MONITORING YEAR 2 ANNUAL REPORT

BANNER FARM MITIGATION SITE

RE: **Banner Farm Draft MY2 Report Review
French Broad River Basin – CU# 06010105
Henderson County
DMS Project ID No. 100062
Contract # 7530**

Wildlands Engineering, Inc. (WEI) has reviewed the Division of Mitigation Services (DMS) comments from the Draft MY2 Monitoring report for the Banner Farm Mitigation Site provided in bold type below and offers the following responses in italics.

2019 Aerial Photography

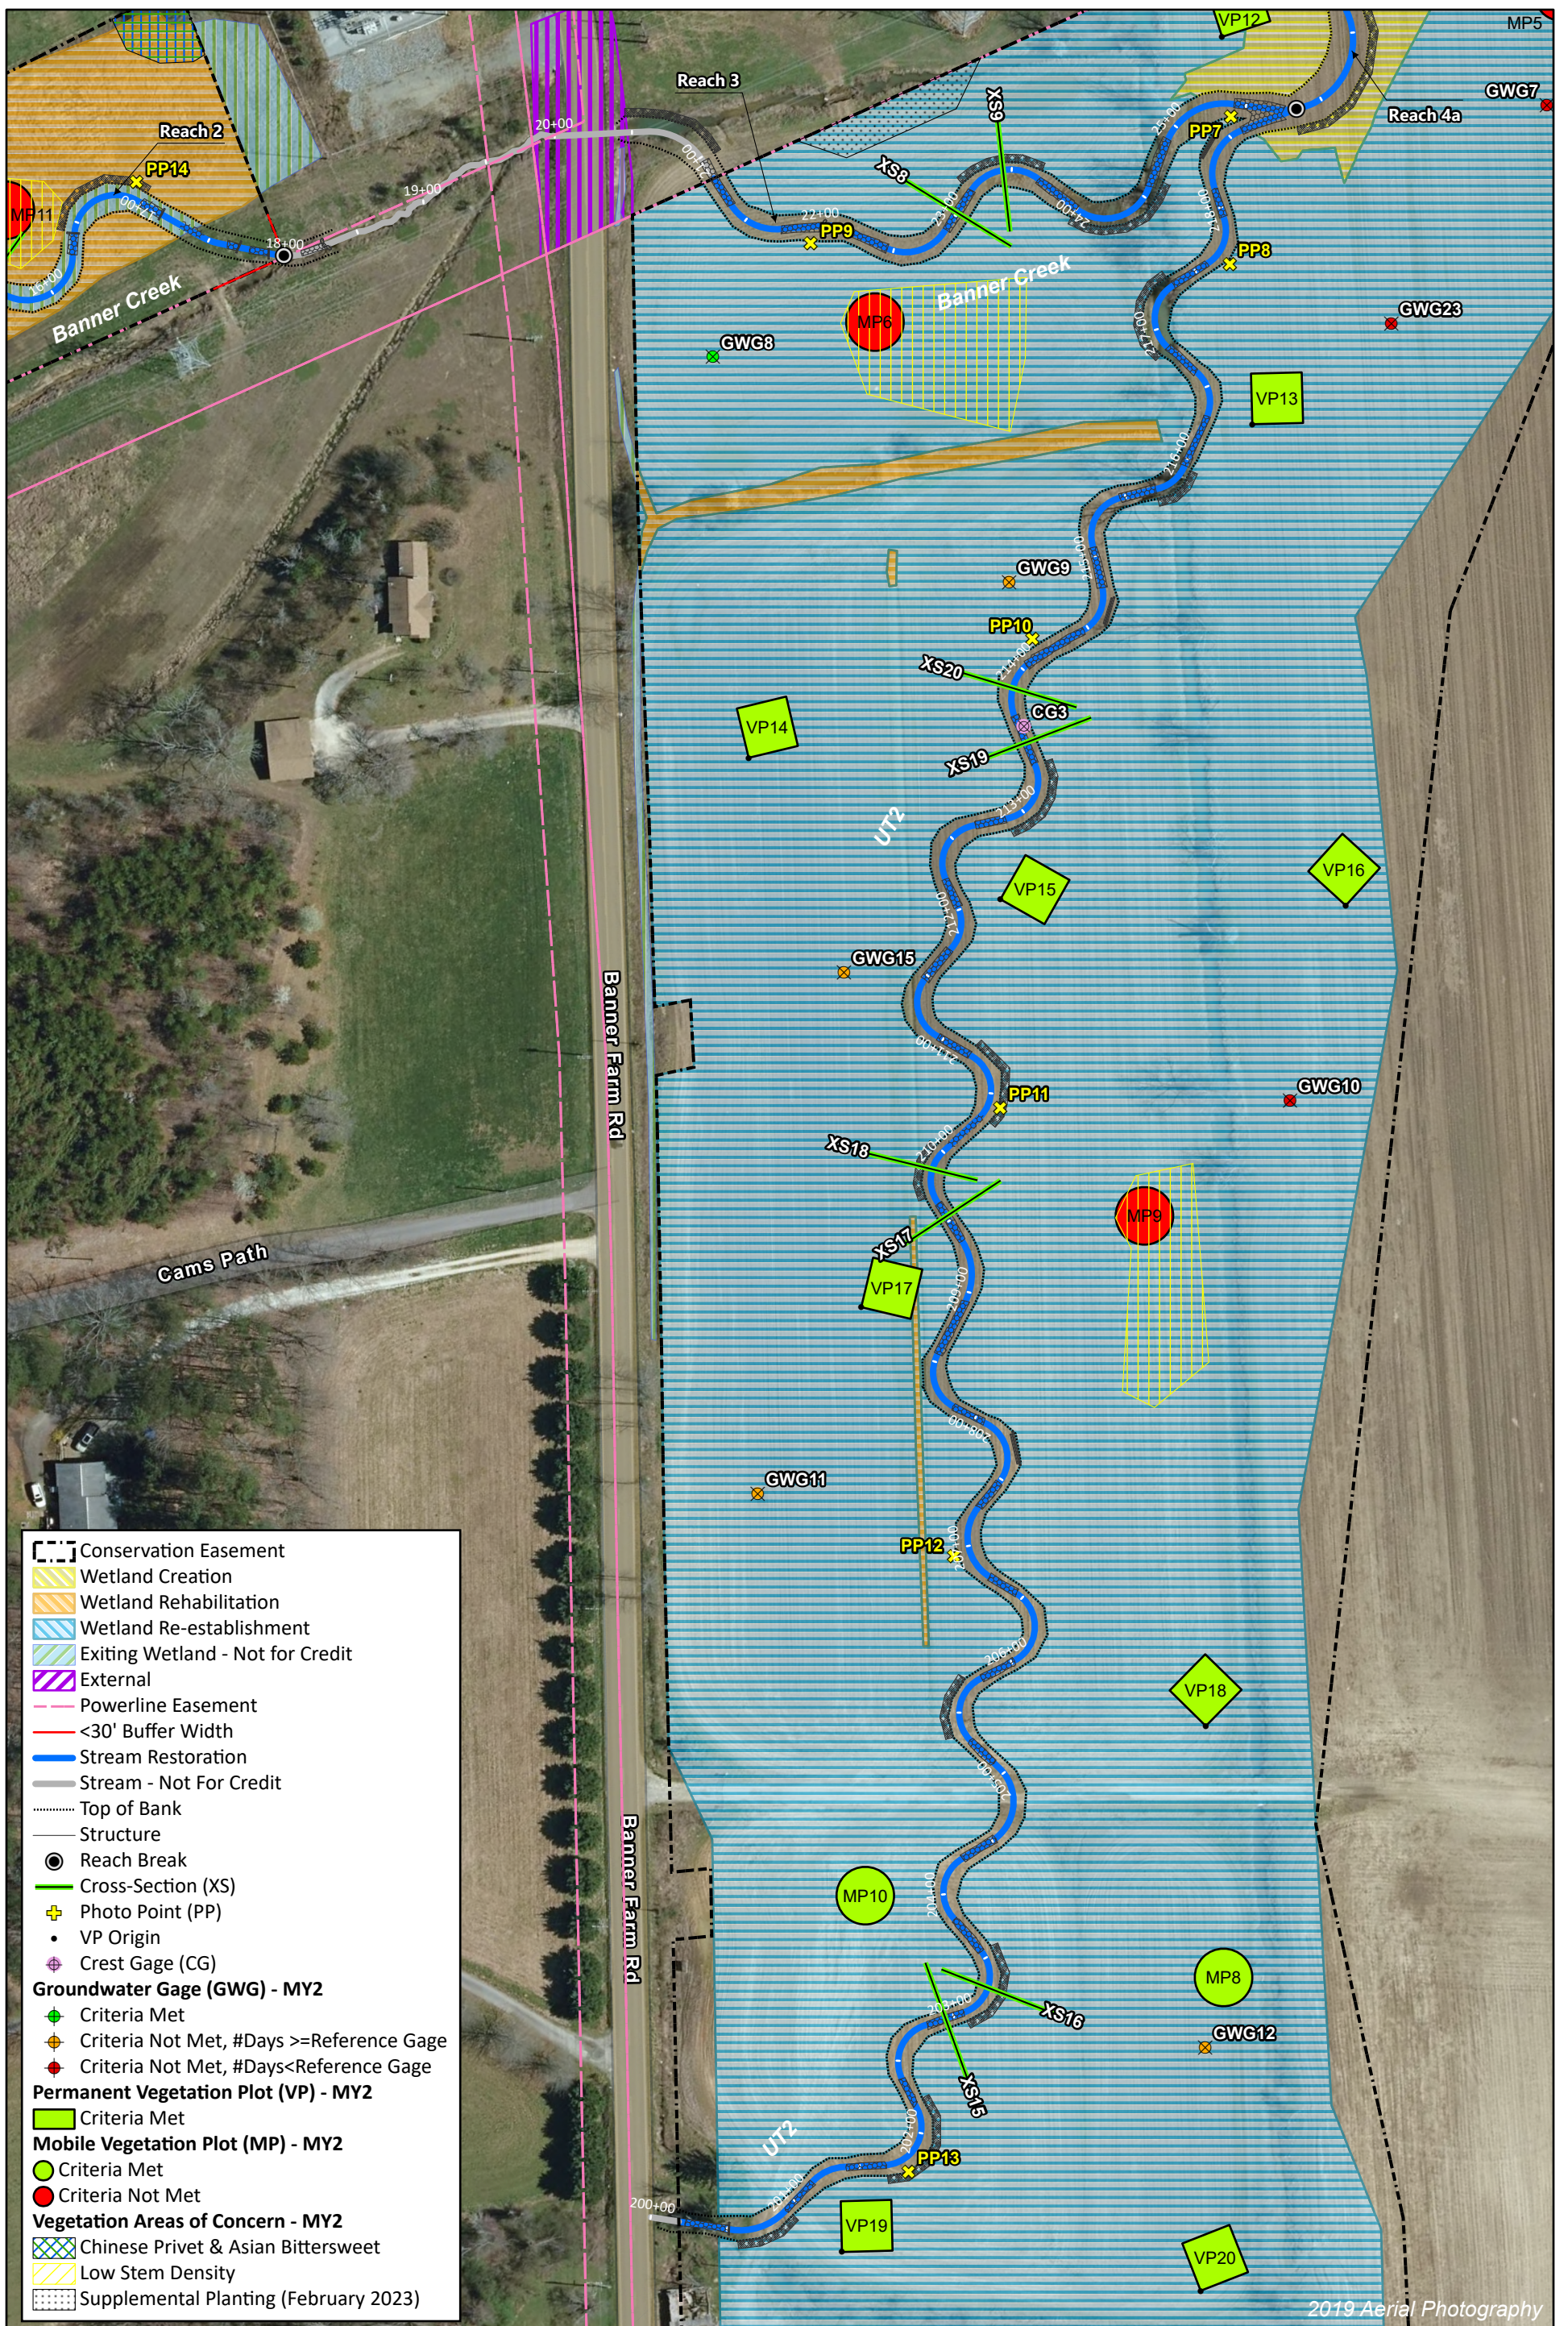
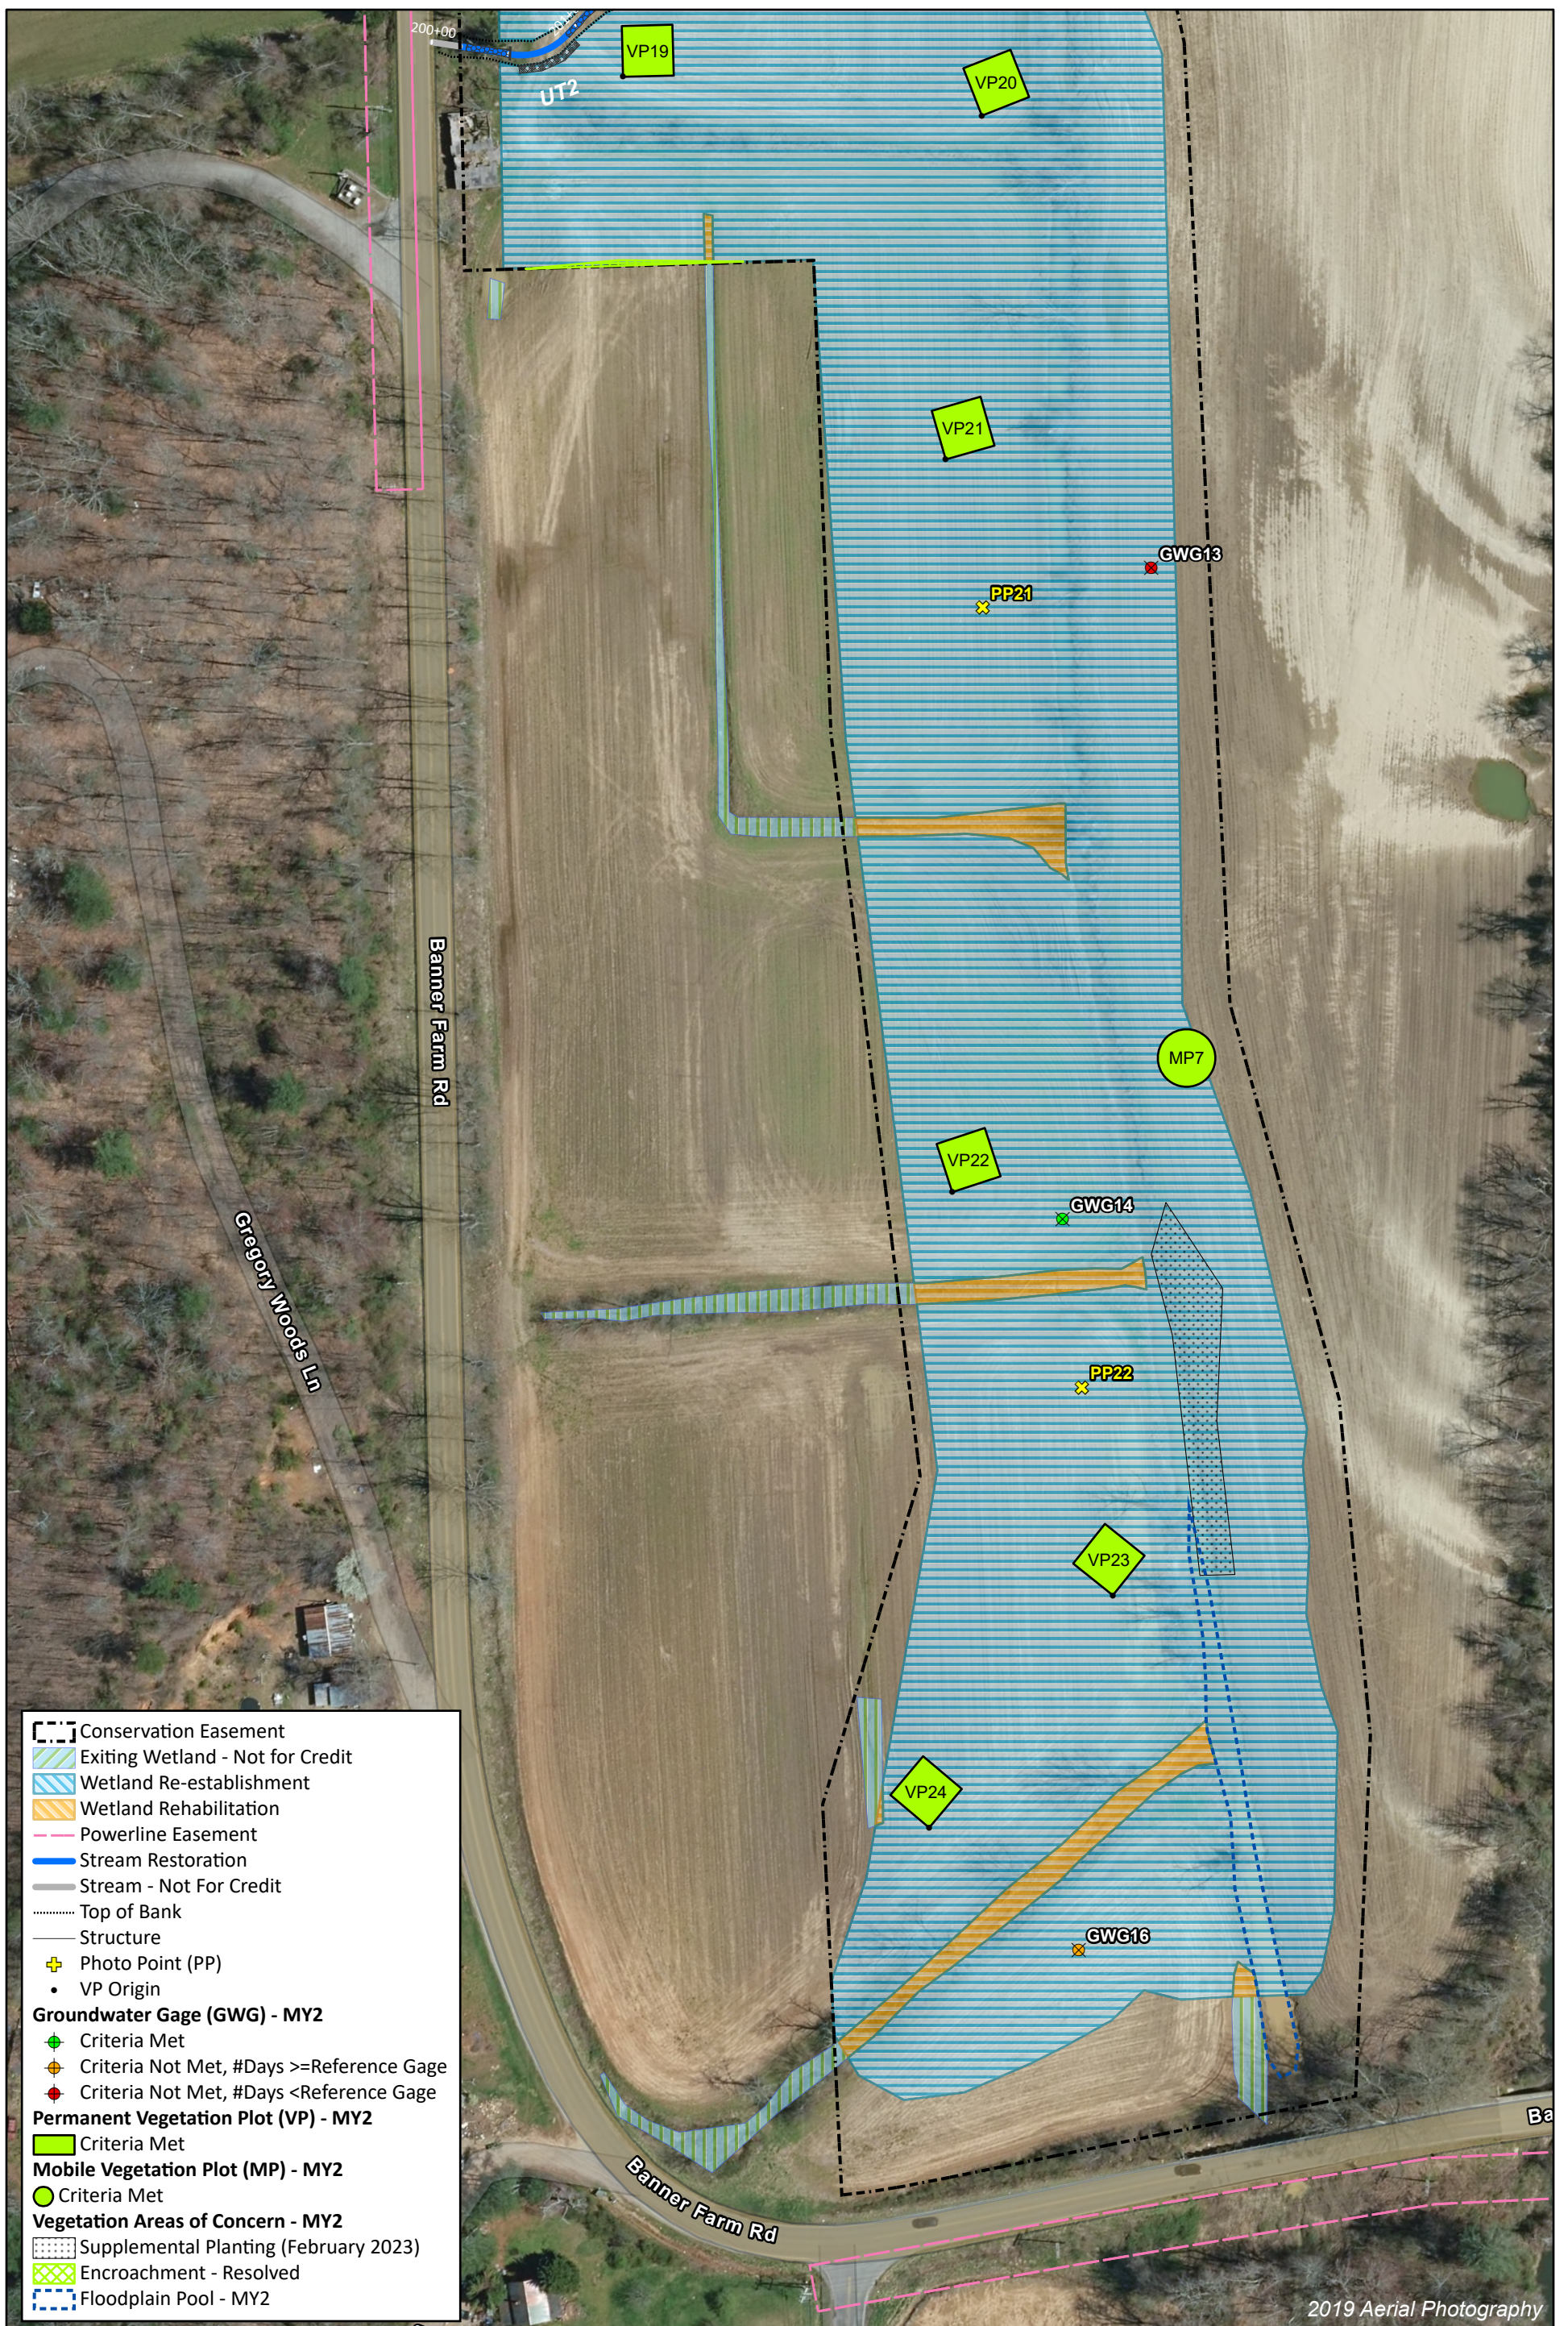
The floodplain pool located in the southernmost portion of the site was planted with live stakes and whips in February 2023. Has this effort been successful? Has the floodplain pool reduced in size? Please show the perimeter of the floodplain pool on the CCPV.

Resolved Easement Encroachments: Thank you for including the Resolved Easement Encroachment List table. This information is greatly appreciated. Please add the location of the resolved easement encroachments to the CCPV.

Wildlands Response: In September 2022 (MY1), herbaceous plugs were planted in the floodplain pool and woody live stakes and whips were added in February 2023 (MY2). These efforts have been successful, and the floodplain pool has reduced in size, though the perimeter varies seasonally. Photos of the floodplain pool have been added to the Supplemental Photographs Log in Appendix A. The current perimeter of the floodplain pool has been added to the CCPV figures.

Wildlands Response: The locations of the resolved easement encroachments have been added to the CCPV figures.

Monthly Rainfall Data
 Banner Farm Mitigation Site
 DMS Project No. 100062
 Monitoring Year 2 - 2023

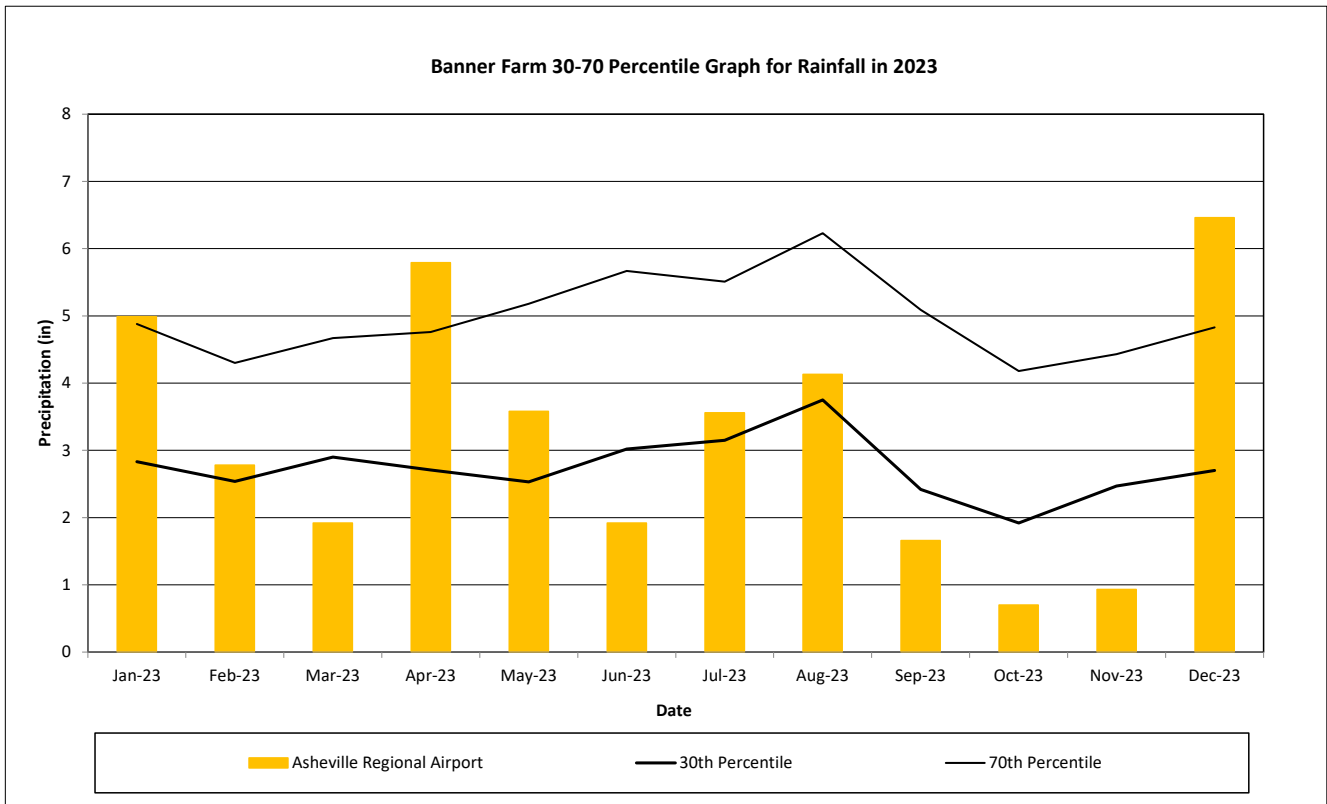
If possible, please update Table 11 Rainfall Summary with end of year data in final submittal.

Wildlands Response: Table 11 and the monthly rainfall data plot have been updated with the end of year data. Text was added in section 2.4 to include the end of year data summary. The 30th and 70th percentile rainfall data was updated to be calculated for the prior 30 years from the WETS station Asheville Regional Airport. The updated rainfall data and WETS table have been included in the electronic support files.
